ADDENDUM NO. 4

Reference: Residential Halls Buildings 2 and 3
Weber State University – Ogden, Utah
DFCM Project No. 10176810 and 11008810

Subject: **Addendum No. 4**

A1 STAIR CHEEK WALL DETAIL

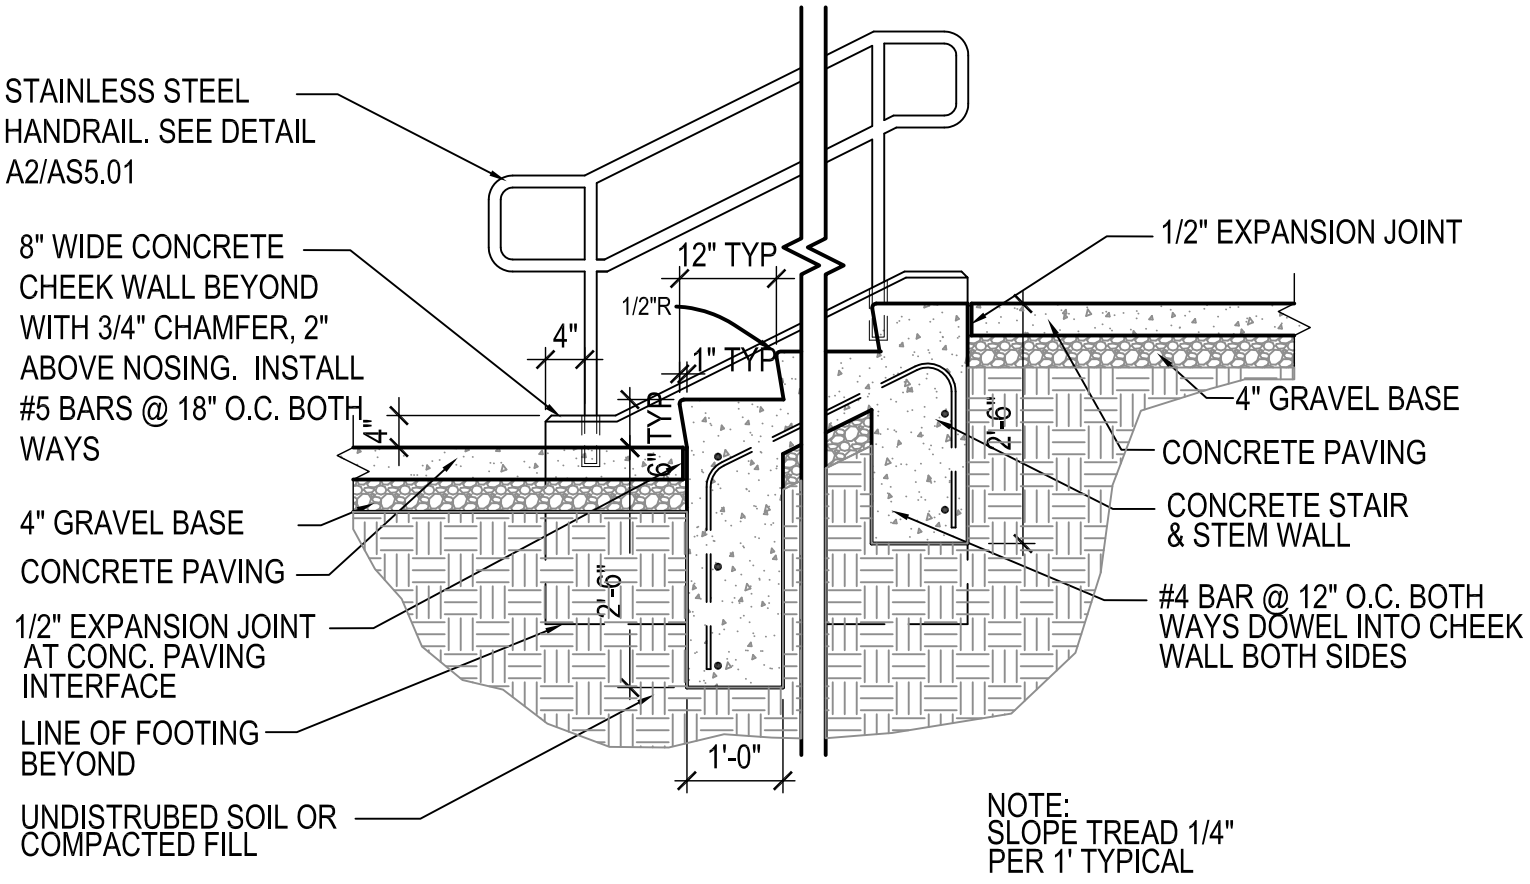
A. Revise Detail A1/AS501. See attached AD04_A01

A2 STONE CAP

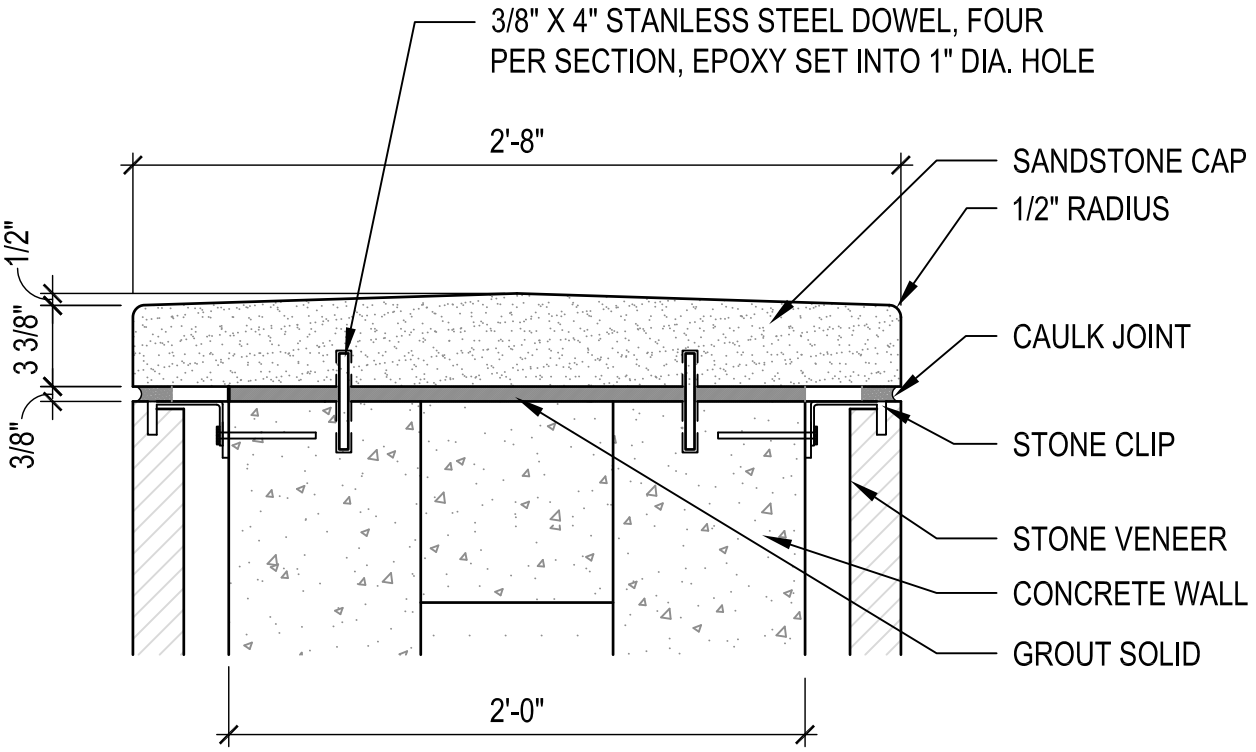
A. Revise Details A1, A2, A3, A4 and A5/AS502. See attached AD04_A02, AD04_A03, AD04_A04, AD04_A05 and AD04_A06.

D5 CONCRETE WALL SECTION

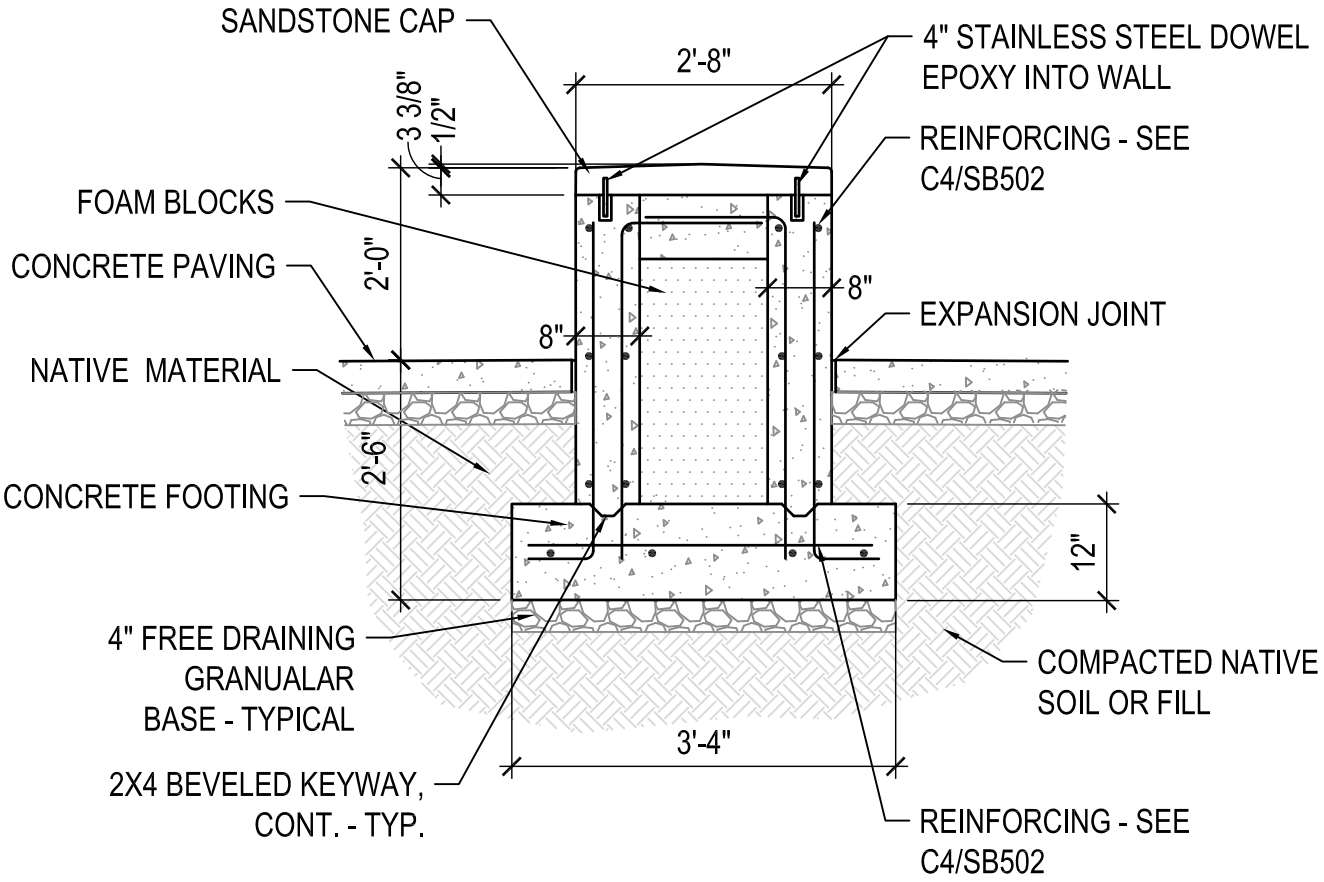
A. Revise Detail D5/AS503. See attached AD04_A07

TREE PLANTING PLAN BUILDING - 2

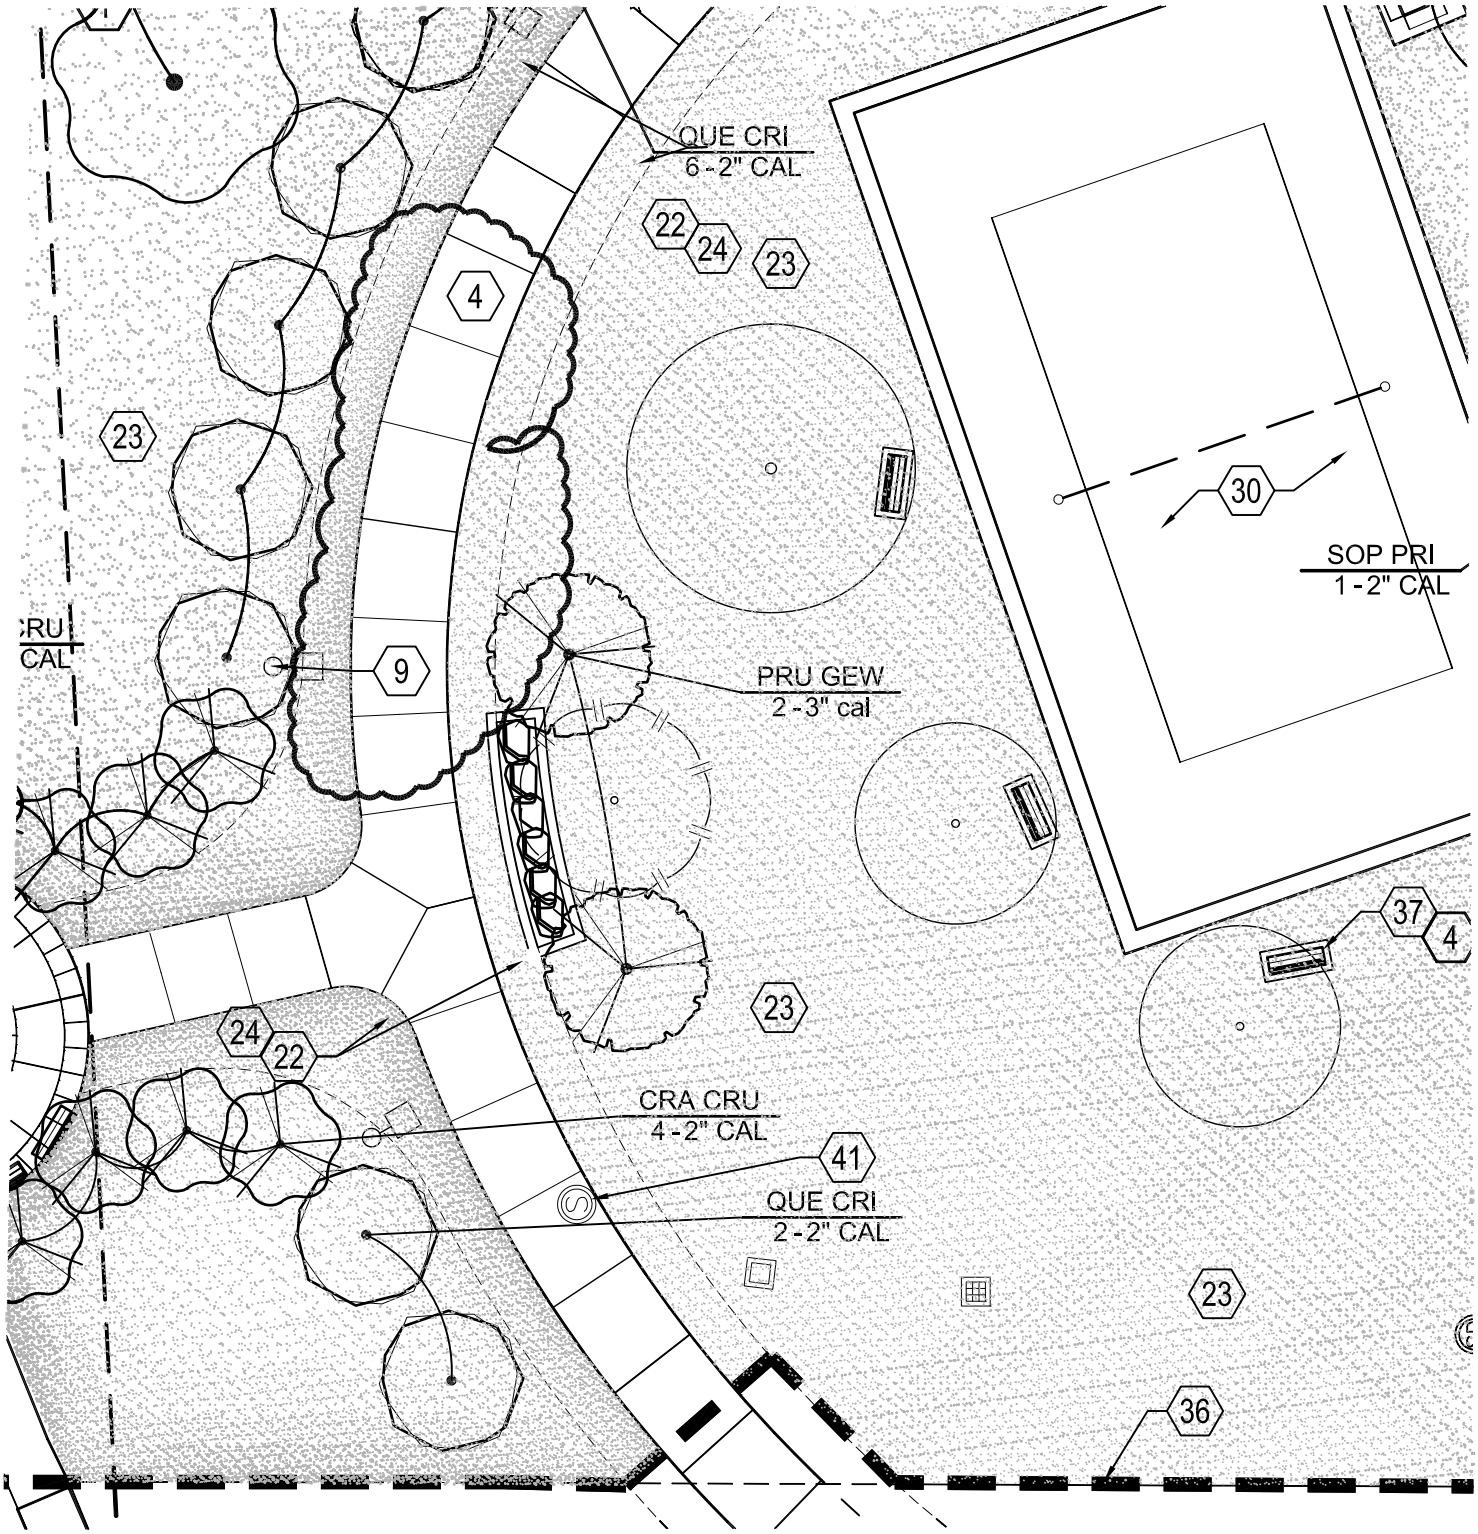
C. Revise plan keynotes as per AD04-L01 and L02.

TREE PLANTING PLAN BUILDING - 2

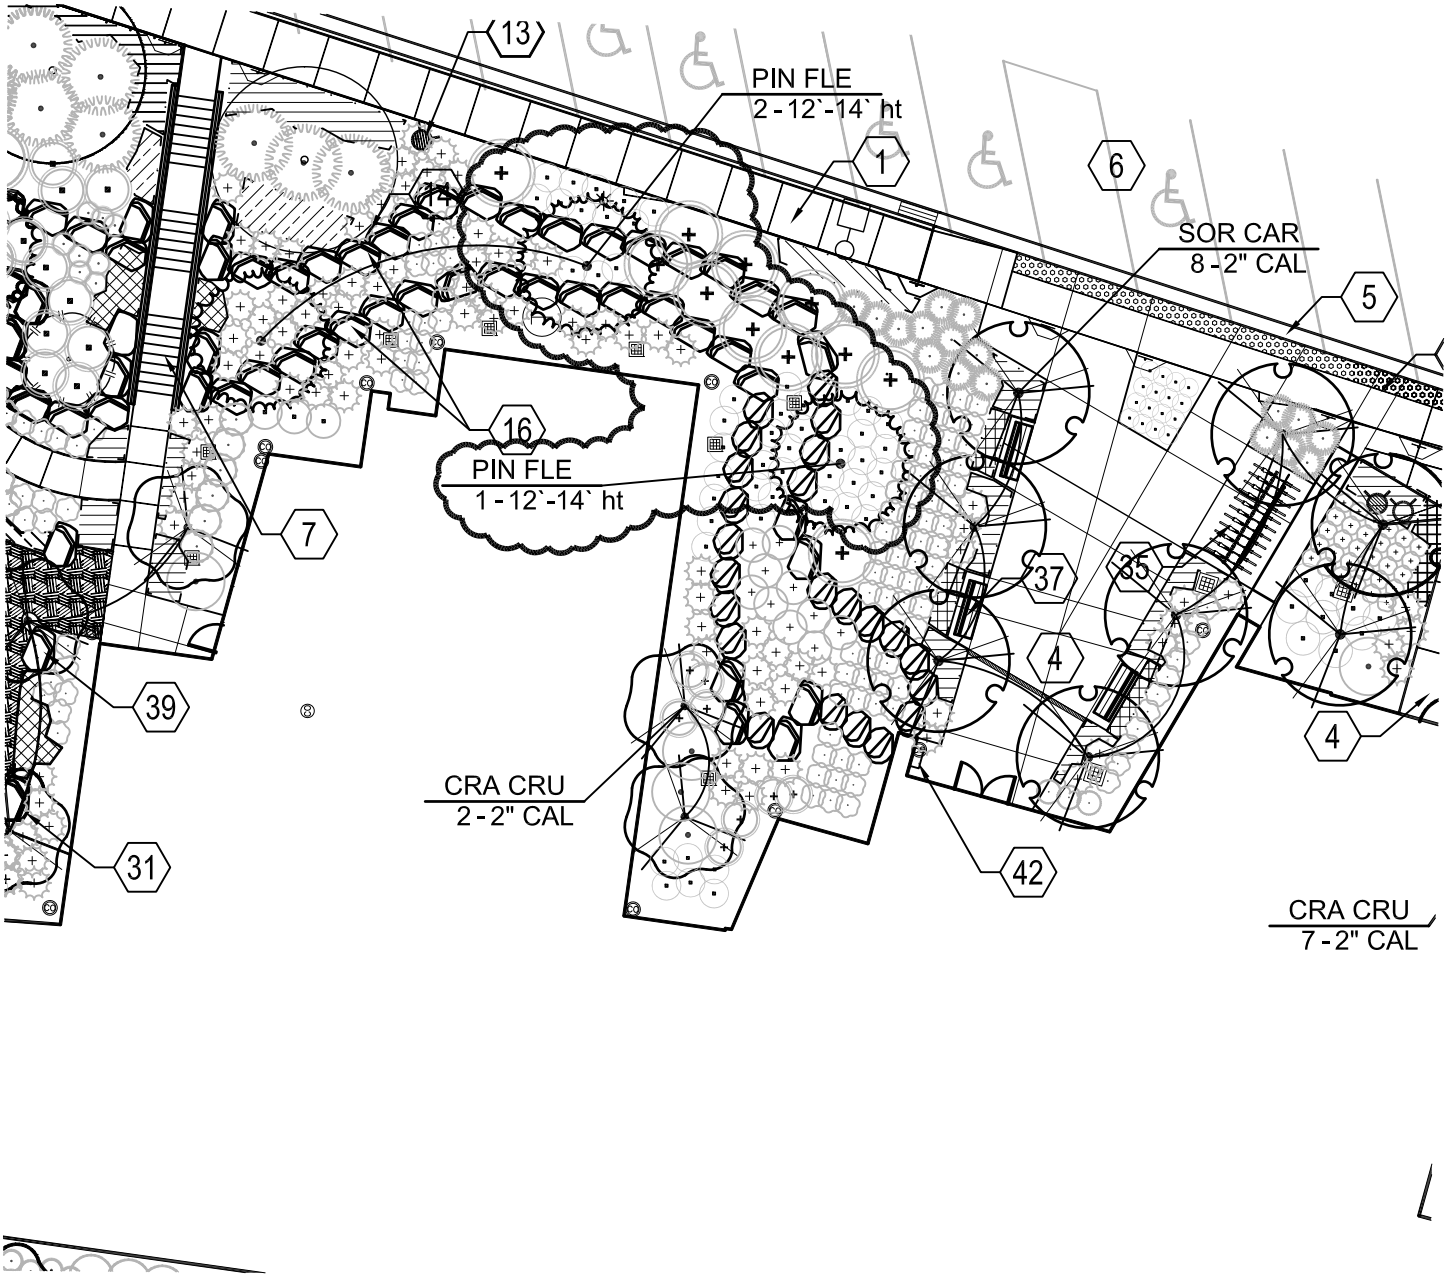
D. Revise the tree layout as per AD04-L03

A1 IRRIGATION PLAN BUILDING - 2

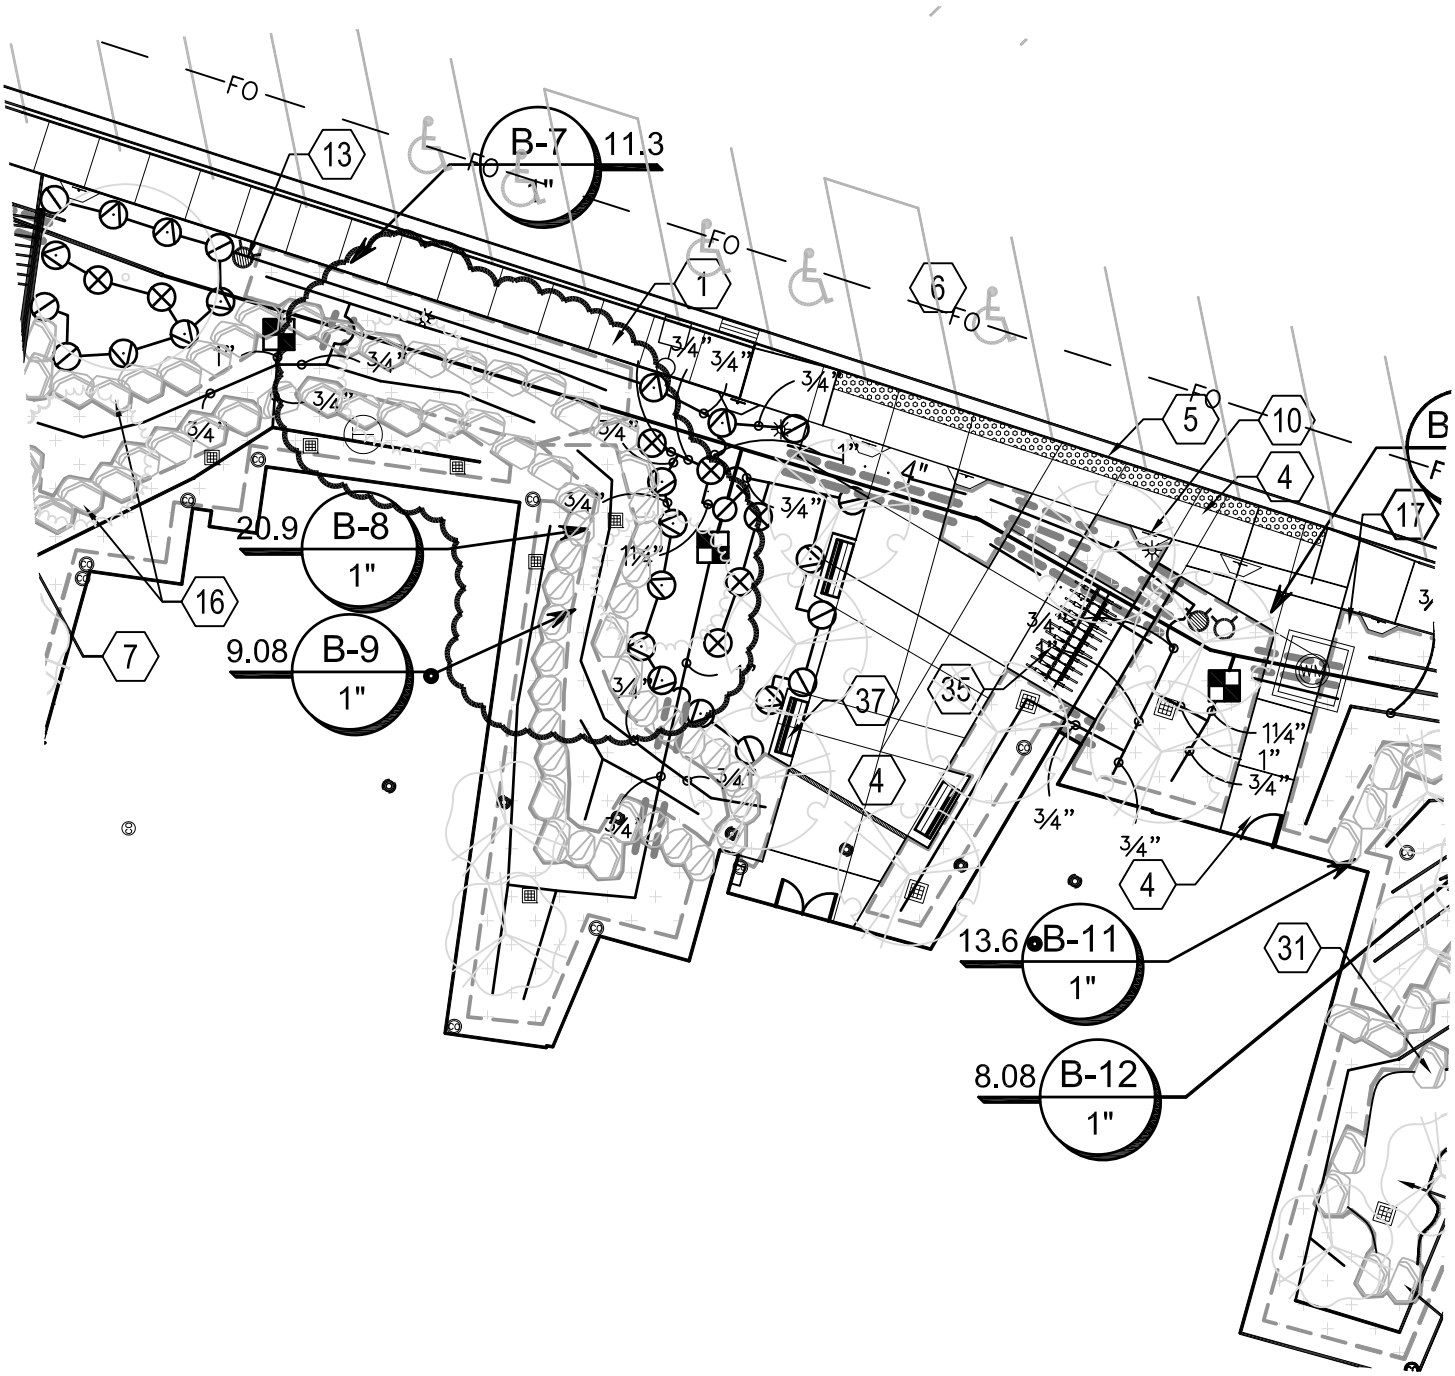
A. Revise the irrigation layout. See attached AD04_L05
